**ROUDABUSH, GALE & ASSOC., Inc.**  
*A PROFESSIONAL CORPORATION Serving Virginia Since 1956*

RE: Revised Belvedere Special Exception  
SE20210005

Attached please find revised documents supporting the above referenced Special Exception.

Figure 1: Original ZM

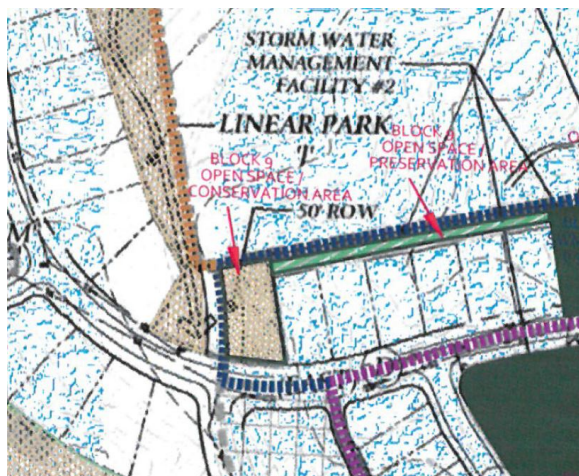
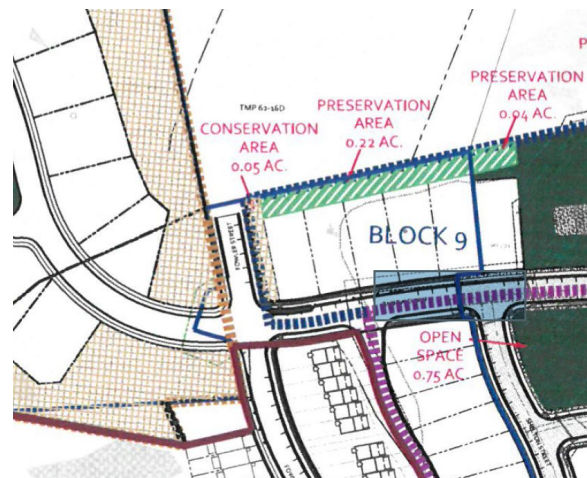
We request removal of Condition #3, Variance #54 and release of the posted landscape bond.

Over the years, the street has gone from the buffered interconnection (Figure 1) to a typical internal intersection (Figure 2). The Application Plan provided an interconnection through Block 9 to an adjacent parcel, TMP 62-16D. The adjacent property has since been purchased and is now being developed as part of Belvedere and the preference is to treat this as an internal intersection versus an interconnection. Our request allows the corner lot to address both streets and the intersection and is more consistent with other intersections with the PUD. The request does not impact the open space tables.
